August 2018
FL752A-D
NHTSA #17V-665
Transport Canada #17-513

Subject: FCCC Bus Chassis Fuel Line Interference

Models Affected: Specific Freightliner Custom Chassis B2 school bus chassis (Thomas Built Buses Saf-T-Liner C2) manufactured August 23, 2011, through September 29, 2017.

Fig. 1, Fuel Line Routing at the Transmission

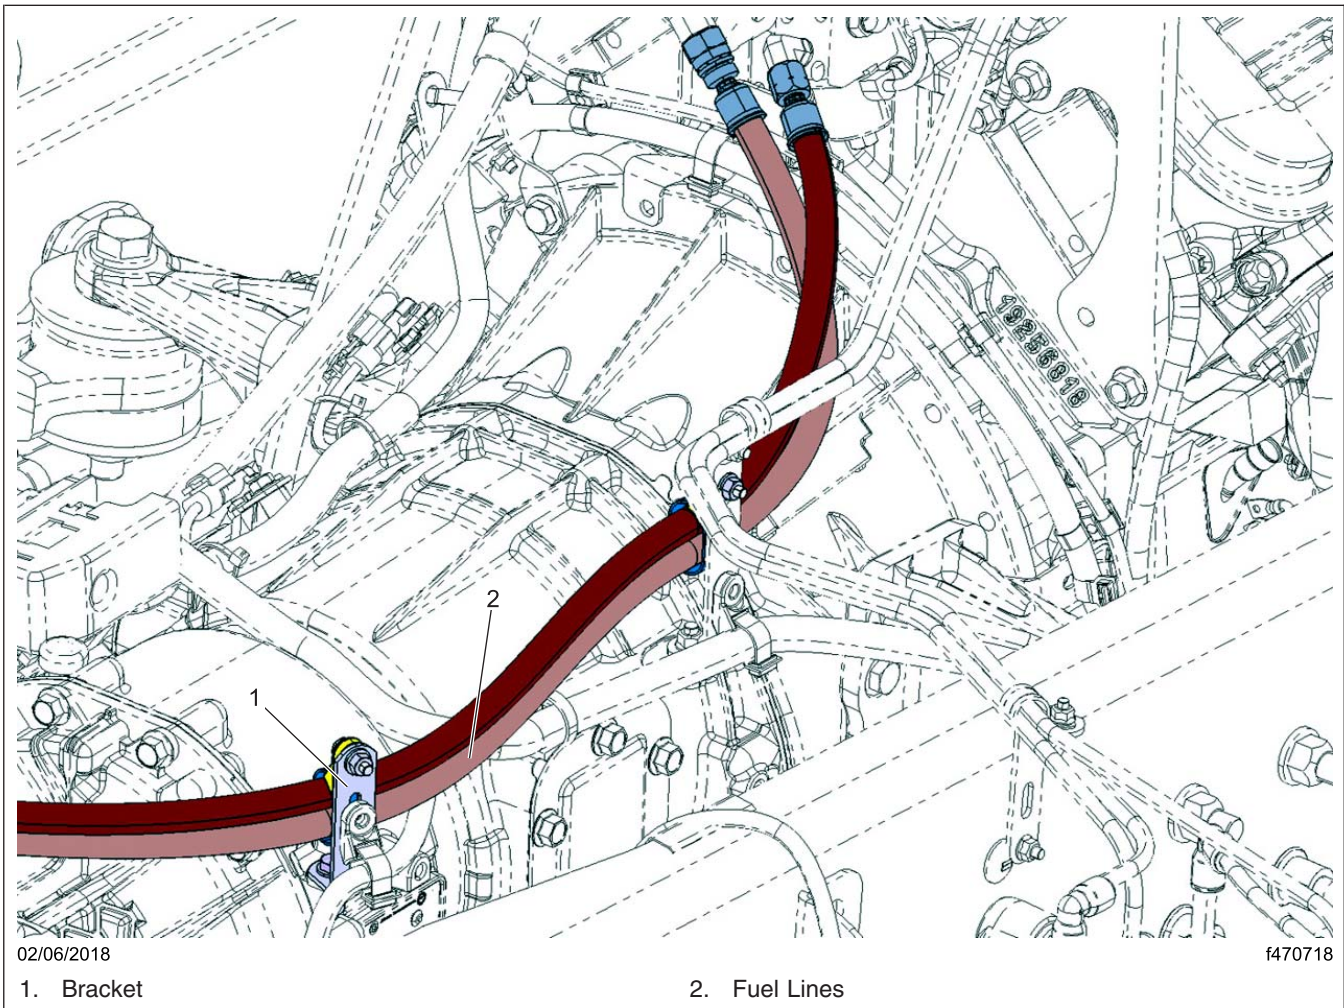
1. Cut the tie band attaching the hoses to the bracket at the rear of the transmission. See [Fig. 1](#).

Fig. 2, Attaching the Hose Clamp

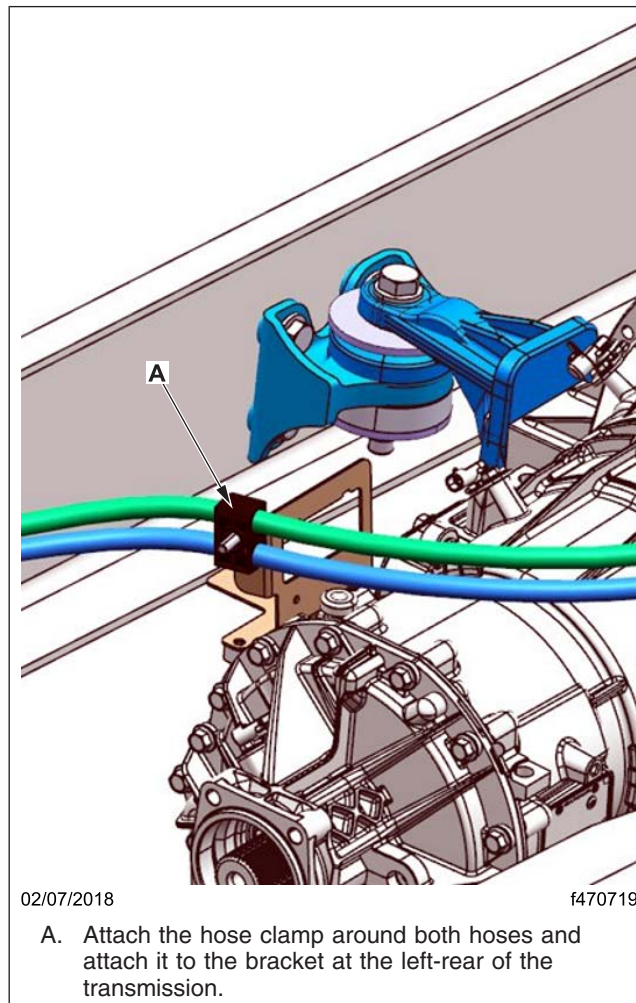
2. Inspect the harness bulkhead mounting bracket located on the driver-side rear of the transmission. If the bracket has a 5/16-inch stud pre-welded, continue with the next step. If not, go to step 4.
3. Attach the hose clamp and the 5/16-inch flange nut from the kit to the existing bracket at the left-rear of the transmission. See [Fig. 2](#).

Fig. 3, Removing the Bulkhead Mounting Bolt

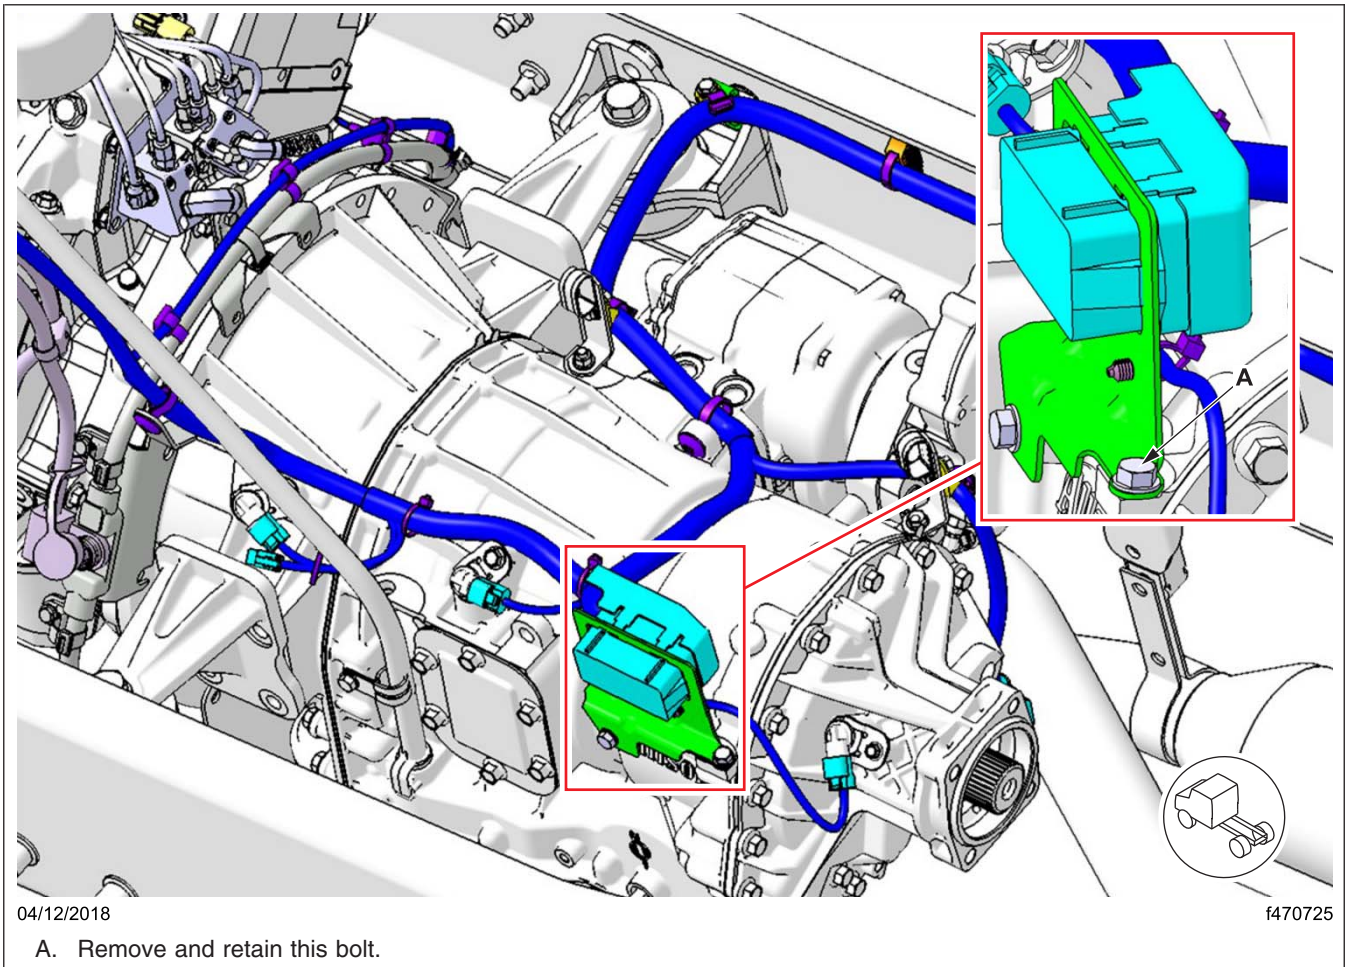
4. Remove the rear bolt from the harness bulkhead bracket on the left-rear of the transmission and set the bolt aside. Using the mounting bolt, install the bracket. Using the bolt, nut, and washers, install the hose clamps. See **Fig. 3** and **Fig. 4**.

Fig. 5, Rotating the Bracket 90 Degrees

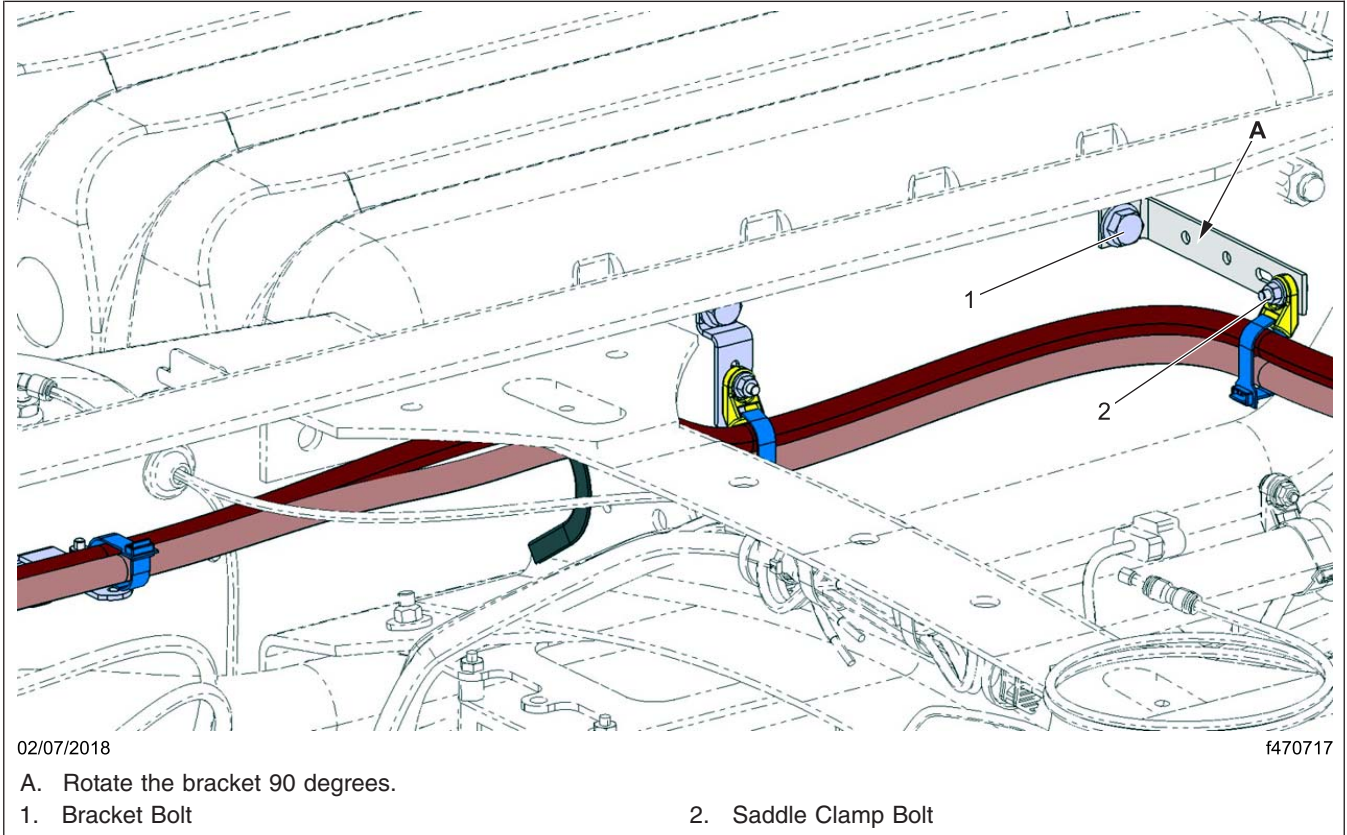
5. Cut the tied band and loosen the bracket bolt and saddle clamp bolt, then reposition the bracket 90 degrees to the position shown in [Fig. 5](#), then tighten the bolts.
6. Attach the hoses to the rotated bracket. If the bus is equipped with optional rear air conditioning (A/C), ensure that the rear A/C hoses are secured and not rubbing the fuel lines. See [Fig. 6](#).

Fig. 7, Securing the Hoses to the Harness

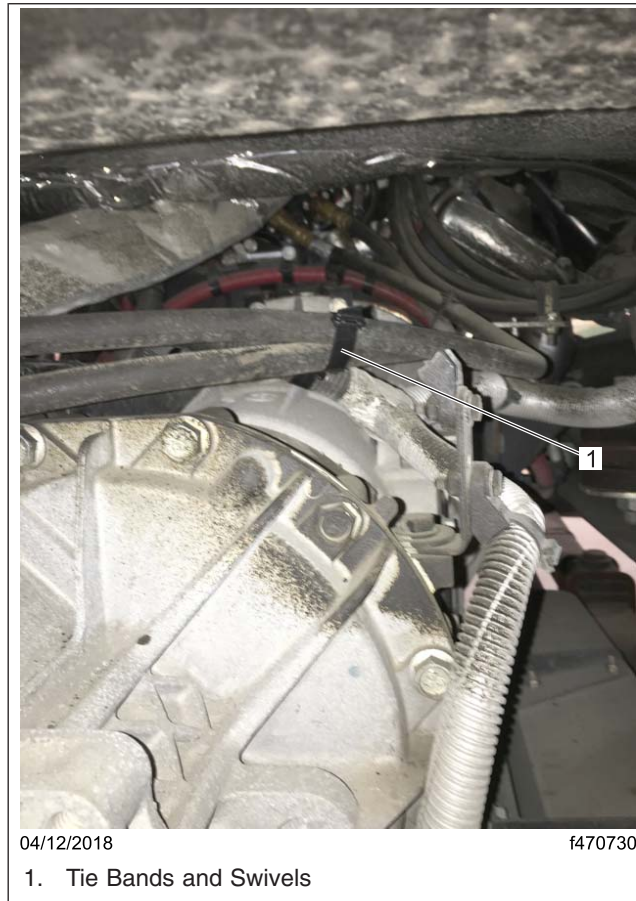
7. Using tie bands and dual swivels, secure the hoses to the harness crossing over the transmission. See [Fig. 7](#).

Fig. 8, Removing the Bracket

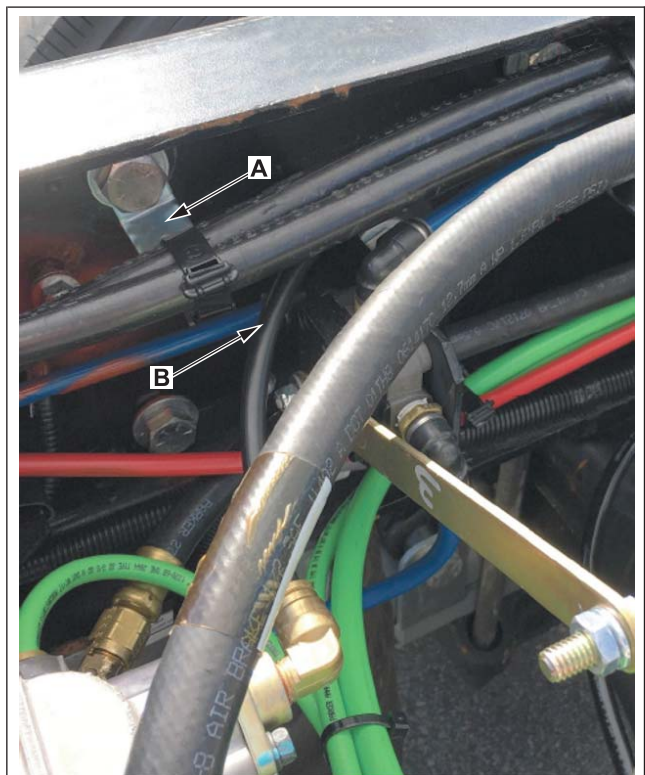
1. To ease assembly, raise the rear of the vehicle and support the frame on jack stands. Allow the rear axle to drop a few inches.
2. Drain the air tanks.
3. Cut the tie strap and remove the existing bracket located above and slightly behind the ride height control valve. Discard the bracket and saddle clamp but retain the bracket mounting hardware. See [Fig. 8](#).
4. Using a 1/4 inch nut, bolt and washer, assemble the saddle clamp on the new L bracket.
5. Install the new L bracket in the same location and hand tighten. Ensure the bracket is rotated down to allow the fuel lines to clear the rear suspension crossmember. Install tie bands around the fuel supply and return lines. See [Fig. 9](#).

- A. Remove the existing bracket.
1. Single Height Control Valve

Fig. 10, Rotating the Bracket, Single Height Control Valve

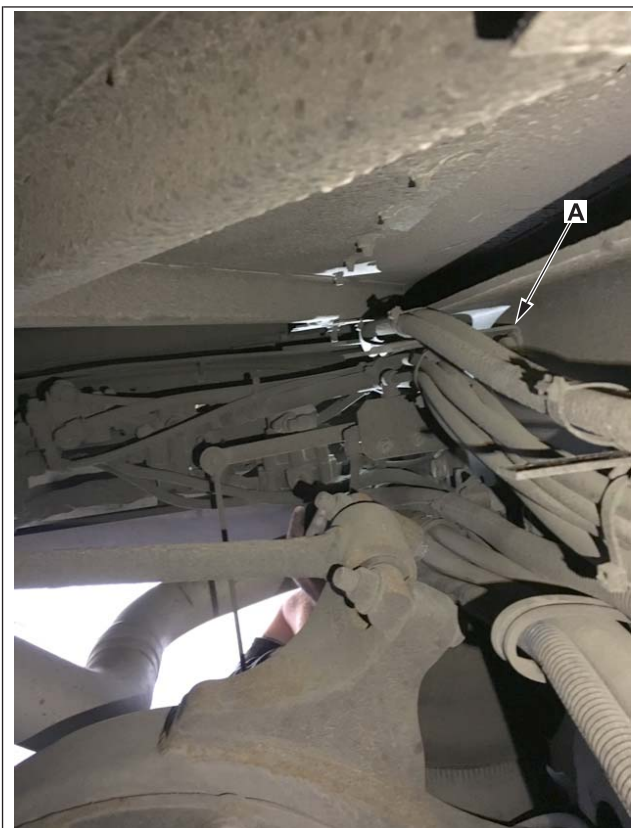
- Cut the tie straps securing the fuel lines to the bracket located above and in front of the height control valve. Loosen and rotate this bracket down 180 degrees then retighten the bracket mounting bolt. See [Fig. 10](#).

NOTE: The threaded part of the bolt must be up to avoid rubbing the fuel lines.

A. Rotate the bracket 180 degrees.

Fig. 11, Installing the Double Cable Tie

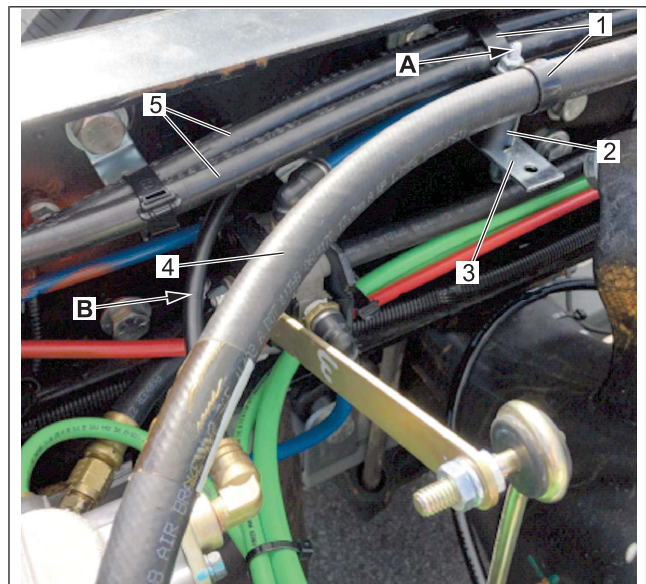
- Install a spacer on top of the bracket, then install a dual cable tie around the service brake air hose and secure it with a bolt and washer. See [Fig. 11](#).

- The threaded part of the bolt must be up to avoid rubbing the fuel lines.
 - This line should be tied up away from the height control valve and tied with the fuel lines in the dual cable tie. Also, using a zip tie (not shown) at the other end of this line, attach the line to the fuel lines for a second clipping point.

Fig. 12, Attaching the Tie Bands and Dual Cable Ties, Rearward View

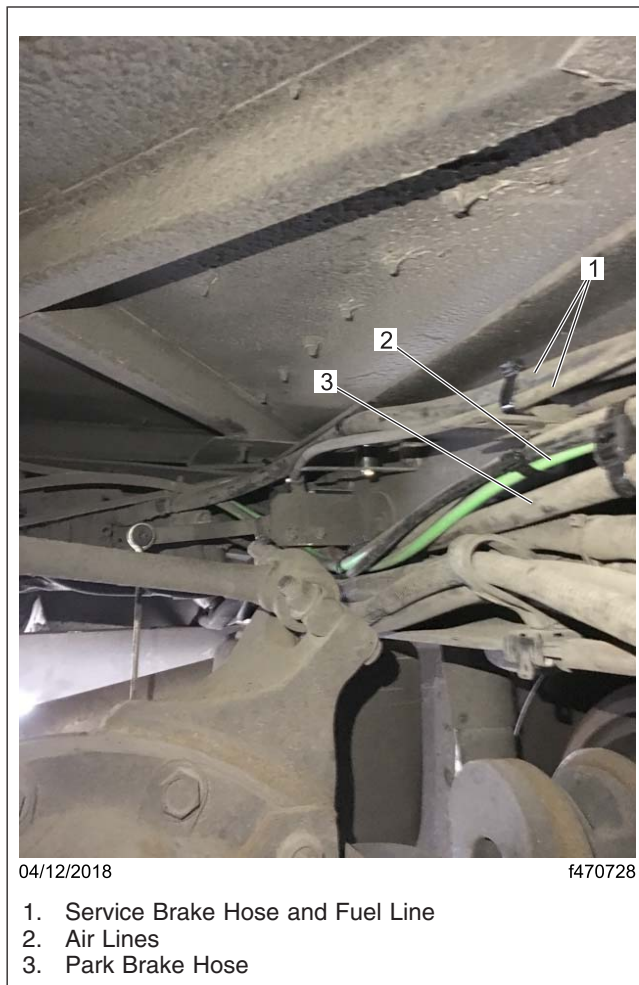
8. Disconnect the red and green air lines at the brake valves and reroute them and the left park brake chamber hose under the height control valve bracket. Connect the lines as shown in **Fig. 12** and **Fig. 13**. Add tie bands and dual cable ties as needed to secure the lines.
9. Using tie mounts and tie straps, secure the hoses to the threaded end of the bottom height control valve bolt inside the frame rail. See **Fig. 14**

Fig. 15, Fuel Line Routing, Rear Suspension Crossmember

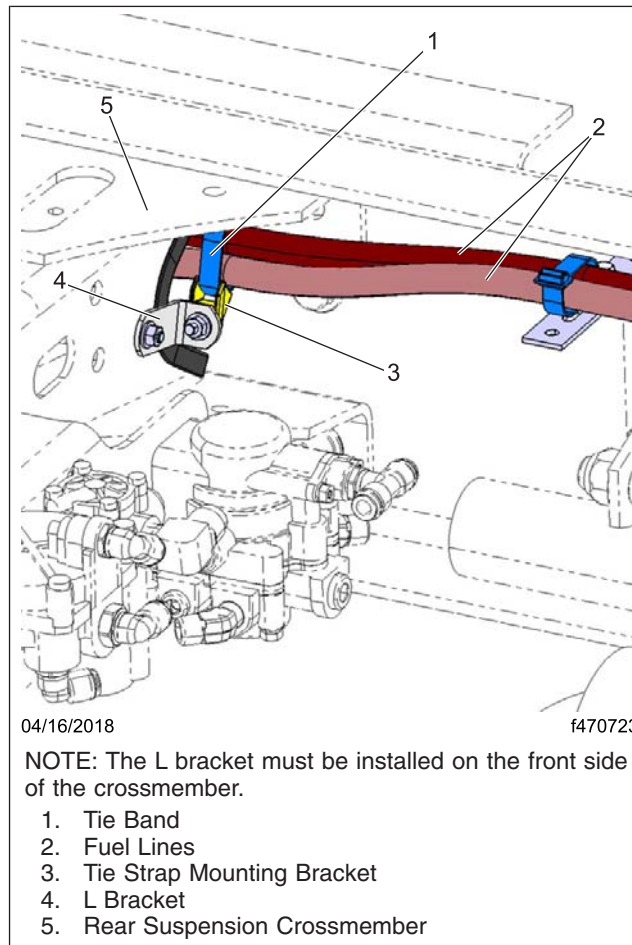
10. Inspect the rear suspension crossmember for an L bracket and tie band mount after the rear axle as shown in **Fig. 15**. Ensure that the L bracket is oriented as shown.

Install an L bracket if not already done.

Fig. 16, Hose and Line Routing, Leaf Spring

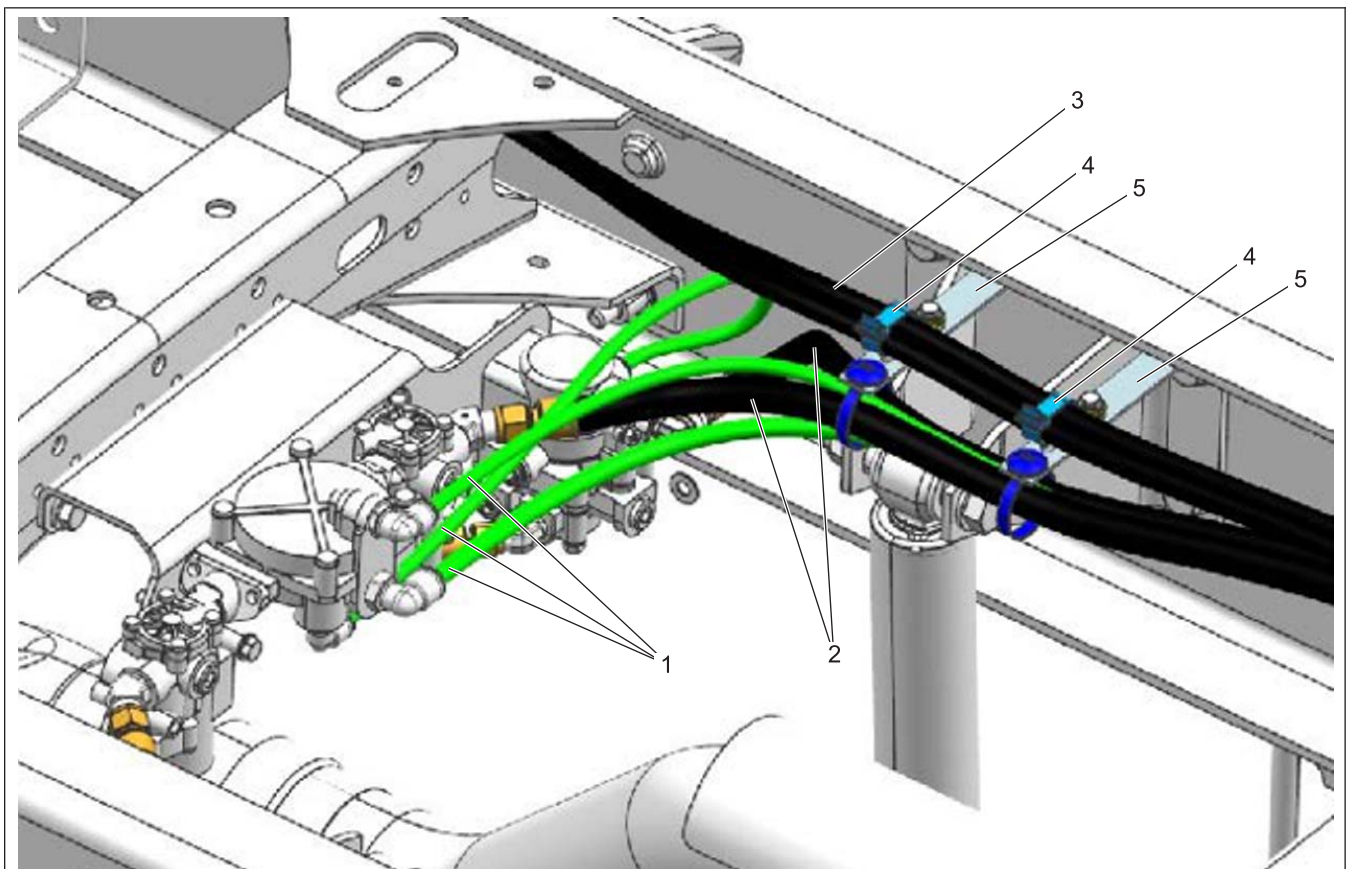
1. Drain the air tanks.
2. Remove all of the tie bands that attach the LPG fuel lines, service brake hoses, and the air lines to the rear brake valve in front and behind the rear axle.
3. Remove the service brake hoses and the green 1/2- and 3/8-inch air lines from the rear brake valve.
4. Remove the top shock bolt and set it aside.
5. Remove both L brackets attached to the top shock mounting bracket bolts.
6. Install saddle mounts on both L brackets.
7. Install the rearward shock mounting bracket bolt removed earlier, as shown in **Fig. 16**. Tighten the bolt 112 lbf·ft (152 N·m).

Then install the L bracket using hardware in the kit.

Fig. 18, L Bracket, Leaf Spring Suspension

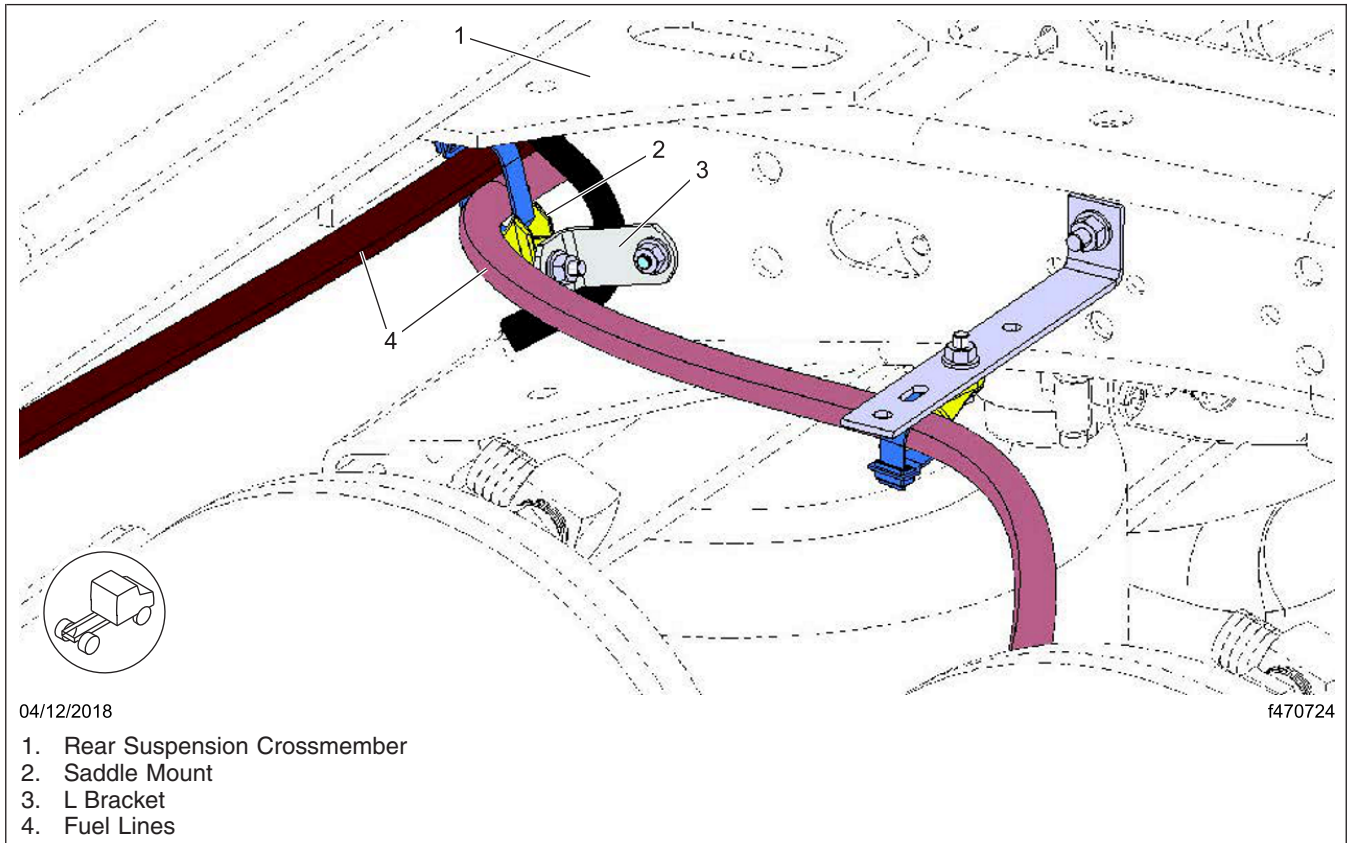
13. Inspect the rear suspension crossmember for an L bracket and tie band mount after the rear axle. Ensure that the L bracket is oriented as shown in **Fig. 18**.
